FRANKLIN MUNICIPAL PLANNING COMMISSION REPORT

NAME OF PROJECT: Pickering West Property, appeal of DRT decision regarding hillside development and slope protection standards

MEMORANDUM

SUBJECT: **Slope Determination for three parcels of property (Map 62; Parcels 18.01, 19.01, and 19.02) located at the southeast corner of I-65 and East McEwen Drive**

CONCEPTUAL
GRADING &
LAYOUT PLAN

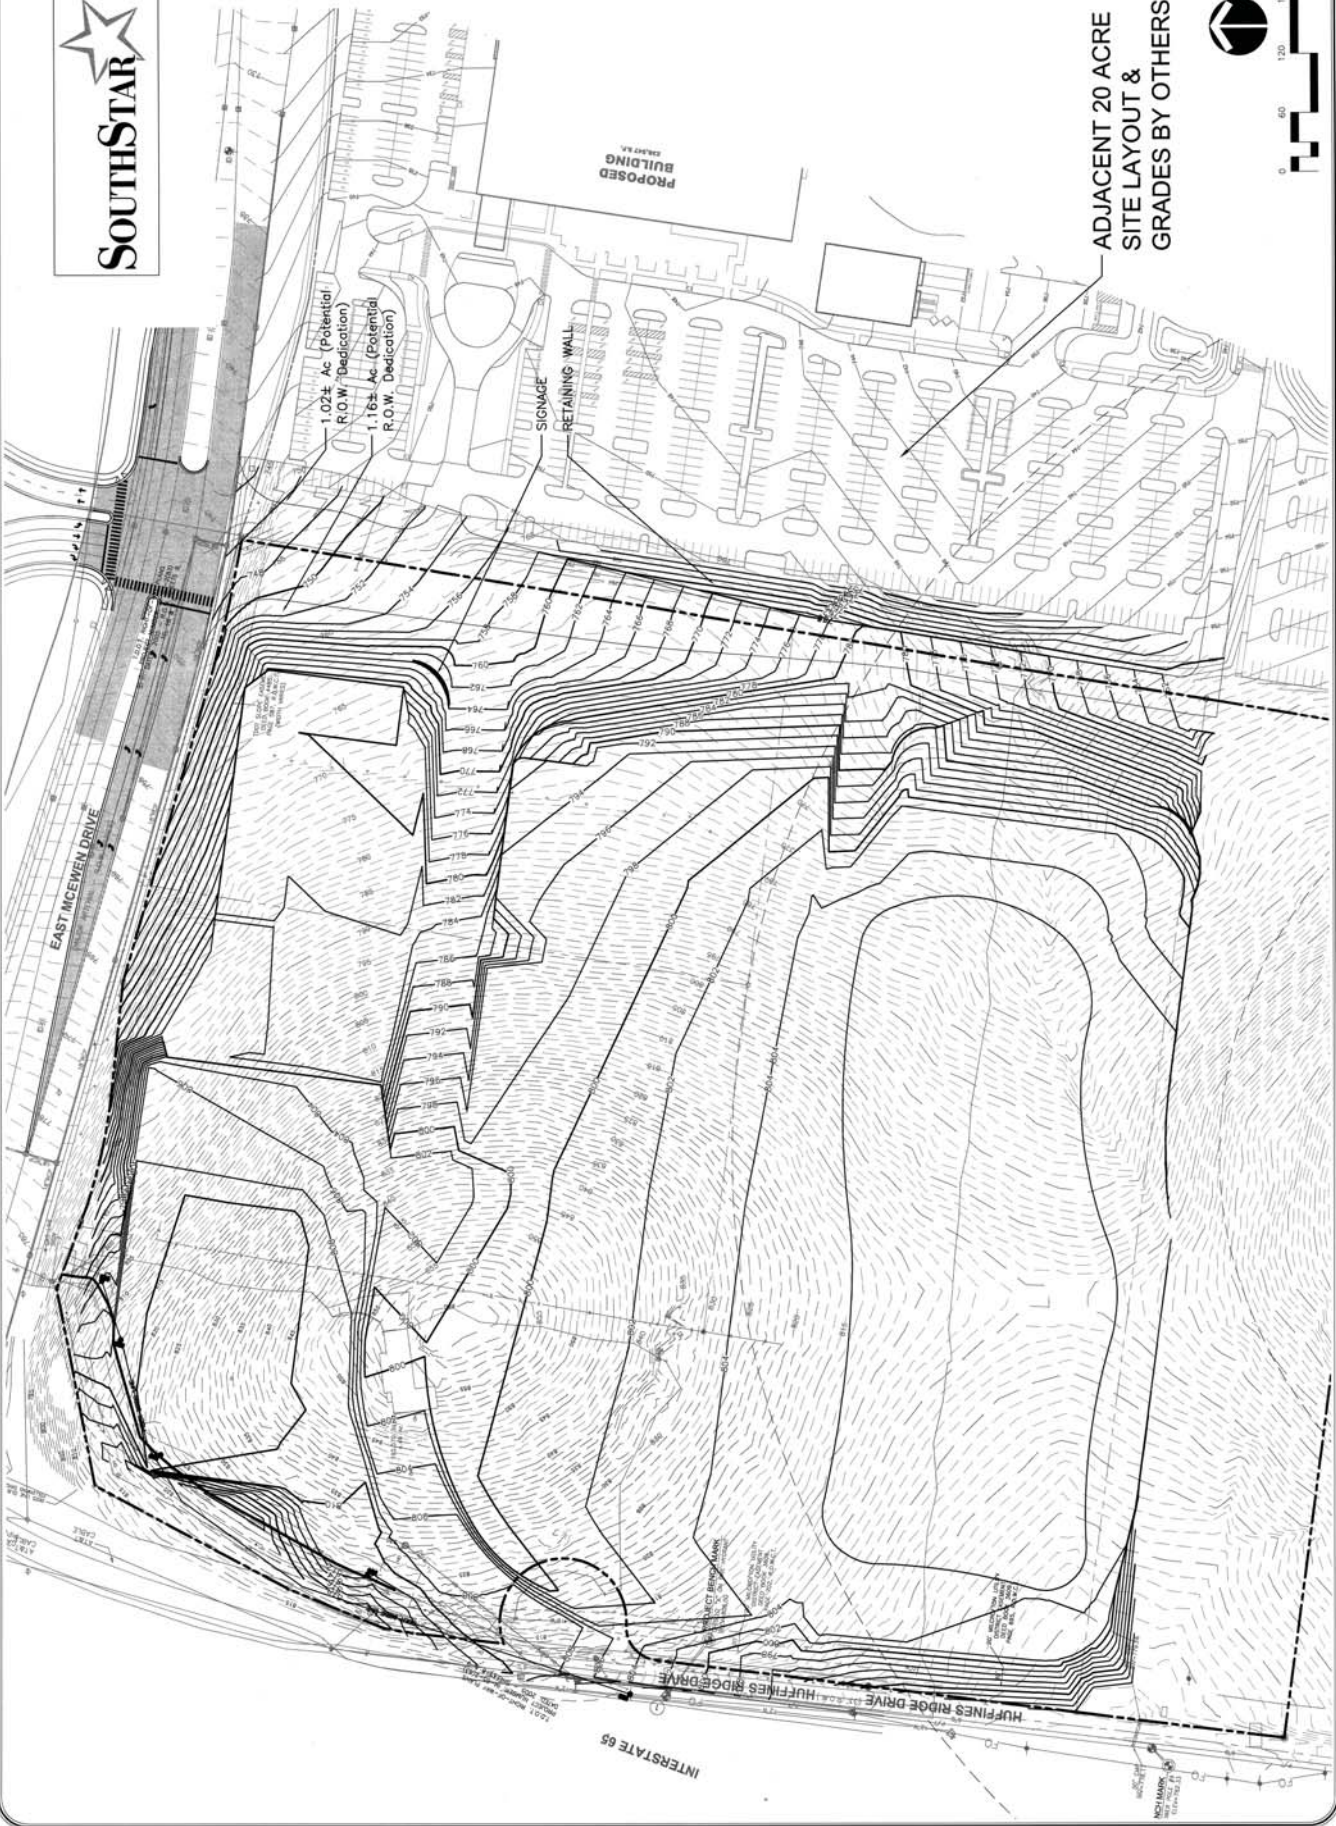
Pursuant to Section 5.8.1(3)(b) of the City of Franklin *Zoning Ordinance*, you have requested a determination on the Hillside Development Standards for three parcels of property (Map 62; Parcels 18.01, 19.01, and 19.02) located at the southeast corner of I-65 and East McEwen Drive in order to lower the hilltop approximately 50 feet for development of the overall site, which would include a connector road identified in the City's Major Thoroughfare Plan. After review of submitted documents and a field visit, the City of Franklin Departmental Review Team (DRT) has made the following determination as to the applicability of the Hillside Development Standards for this property (see attached exhibit for a graphic depiction of this determination):

- The area within the Hillside/Hillcrest Overlay Zoning District (HHO) and the areas of 14 and greater percent slope in the 500' buffer of the HHO fall under the requirements of the Hillside Development Standards in Section 5.8.1 of the *Zoning Ordinance*
- The areas of 14 and greater percent slope on the northeastern portion of the total property, delineated in green on the attached exhibit, are considered to be a site with area-wide benefit for slope protection, and, therefore, falls under the requirements of the Hillside Development Standards in Section 5.8.1 of the *Zoning Ordinance*
- The areas of 14 and greater percent slope outside of the HHO, the 500' HHO buffer, and the area delineated in green on the attached exhibit are considered to be a site with limited benefit and, therefore, are exempt from the Hillside Development Standards in Section 5.8.1 of the *Zoning Ordinance*.

The Franklin Land Use Plan encourages balancing the protection of environmental resources with the ability to reasonably develop a property, but not at the expense of compromising neighborhood character. With this principle in mind, DRT has evaluated the various areas of steep slopes on these properties. DRT has concluded that the most important area of preservation is the view of the hillside and hilltop from the southbound I-65 corridor. This is currently the most scenic view of the hillside. It is likely that mid-rise buildings may be developed just east of the hill, thereby, blocking some of the view of the hill from the east. Consequently, DRT has determined that the area of 14 and greater percent slopes on the east side of the hill, not immediately facing East McEwen Drive, may be graded and developed. However, the slopes visible from the north and west should be preserved to maintain some sense of topographic integrity.
